**TOWN OF PORTOLA VALLEY
ARCHITECTURAL AND SITE CONTROL COMMISSION (ASCC)
Monday, April 22, 2013
Special Joint Field Meeting (time and place as listed herein)
7:30 PM – Regular ASCC Meeting
Historic Schoolhouse
765 Portola Road, Portola Valley, CA 94028**

a. Follow-up Review for Landscaping and Exterior Lighting Related to Proposed Residential Additions, Remodeling and Guest House, 230 Shawnee Pass, Gurtner

b. Preliminary Architectural Review for New Residence with Detached Pool House, Swimming Pool and Horse-keeping Facilities, and Site Development Permit X9H-649, 117 Pinon Drive, Divita

TO: ASCC
FROM: Tom Vlastic, Town Planner
DATE: April 22, 2013
RE: Agenda for April 22, 2013 ASCC Meeting

Architectural Site Plan with Landscape and minor Grading

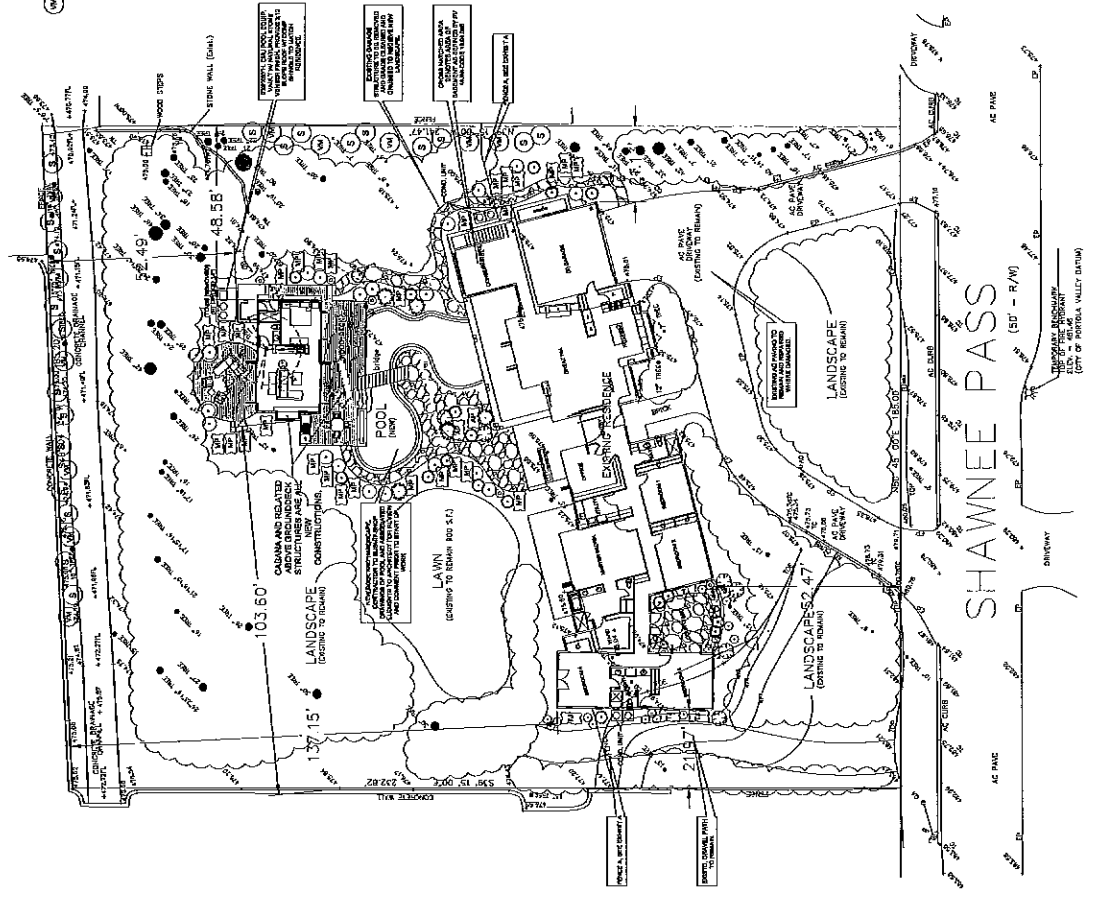
1. **Landscaping.** The revised landscape plan shows rows of screening shrubs consisting of vine maple and mountain laurel interspersed amongst each. On the southerly property line, the shrubs are planted between the concrete block wall and the drainage ditch. Along the westerly property line, the screening shrubs are located between the row of redwoods coming down from the street and the row of redwoods in the rear yard. Some additional clustering of the shrubs should be considered to create a more natural landscape element. The plans also show the removal of the concrete driveway that provided access to the detached garage to be replaced it with a narrow walking path and groupings of plants. Additional shrubs have also been planted next to the patio at the back of the cabana.

The landscaping at the front of the house will remain unchanged as will the gravel path the provides access to the back of the house, the rear yard landscaping and the existing rear yard lawn, which is under 1,000 square feet. Staff understands the desire of the applicant to retain the gravel path to provide access to the rear yard, especially during the construction period. However, the path does increase the amount of impervious surface on the property, therefore, staff recommends that it be replaced with a walking path and native, low water landscaping prior to building permit final.

2. **Fencing.** The plans indicate two new short sections of fencing between the house and the side property lines. The architect will provide samples of the proposed fencing at the meeting.
3. **Exterior Lighting.** All existing exterior lighting will be removed. The Commission specifically requested that the originally proposed driveway lighting be removed and

FRONT ELEVATION (NORTH-WEST FACING)

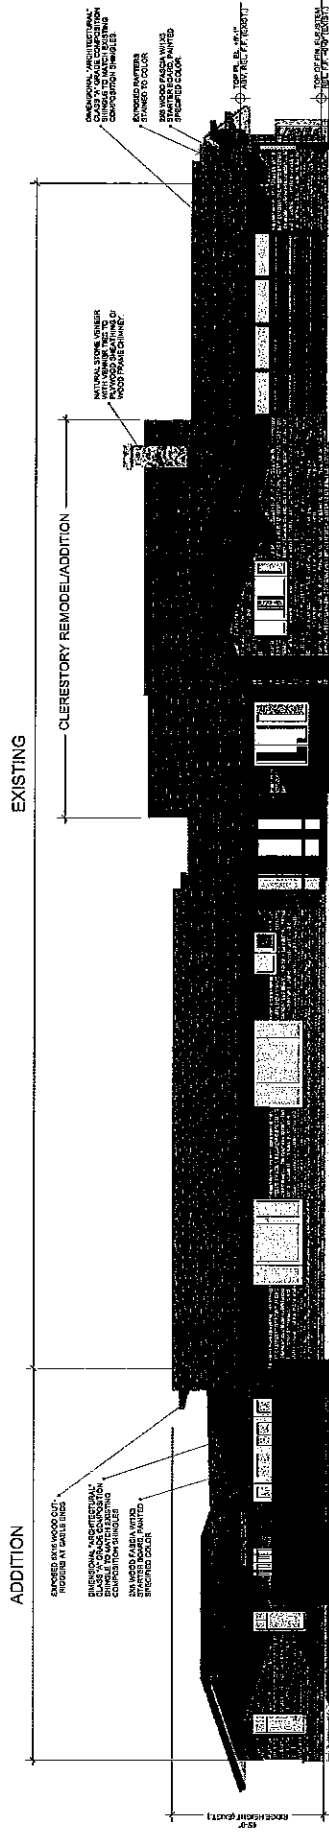
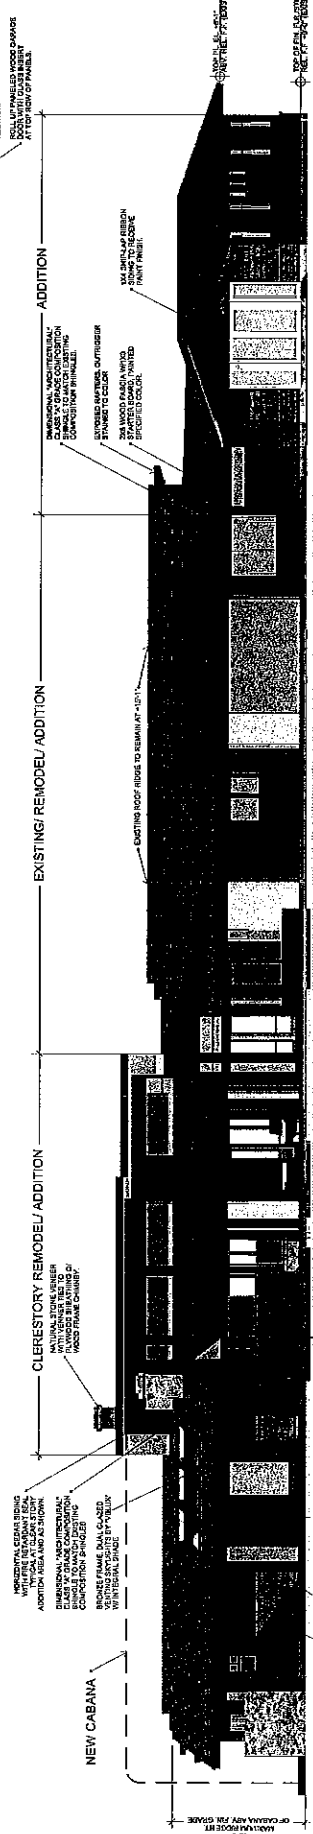
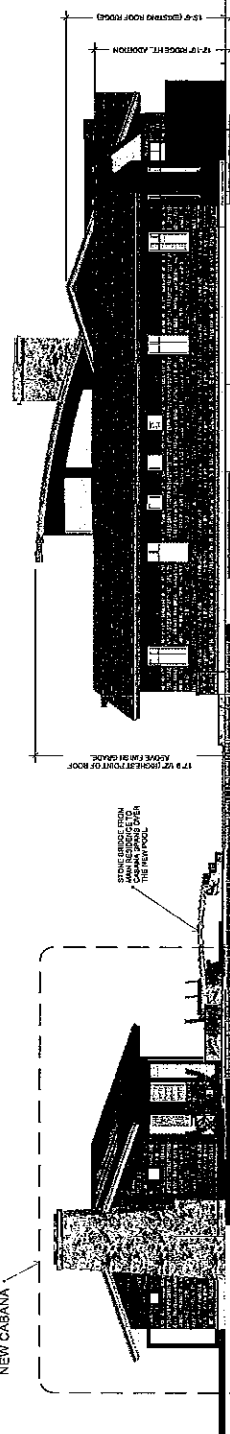
2. **Window and door finish treatments.** The new elevation drawings show white framed, vinyl windows on the front elevation and on the front and sides of the new bedroom wing to match the existing white framed vinyl windows. In addition, the exterior doors at the rear of the bedroom wing addition utilize white framing. The trim around all new vinyl

Staff's recommendation on the doors and windows would be to change the rear doors on the bedroom wing addition to the dark toned, aluminum clad units to match the proposed doors at the rear of the house and keep the design consistent.

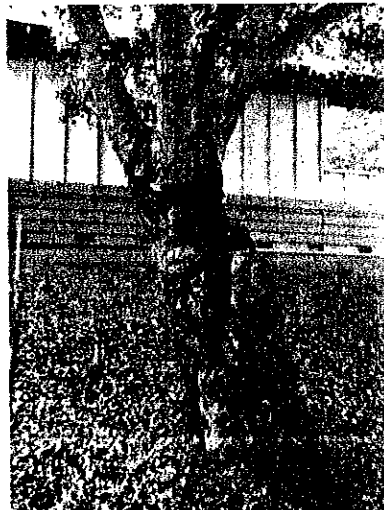
Tree # 90 (see in image to right) suffered a co-dominant limb failure in its past and has some structural weakness in its trunk. This tree leans away from the proposed construction and the clients have opted to retain this tree at this time.

Tree #89 (see in image to right) also suffered a major co-dominant limb failure in its past and has severe trunk decay. This tree was also topped in the past and has four poorly attached co-dominant scaffold limbs. This tree needs to be removed for construction and for structural reasons as it represents a hazard.
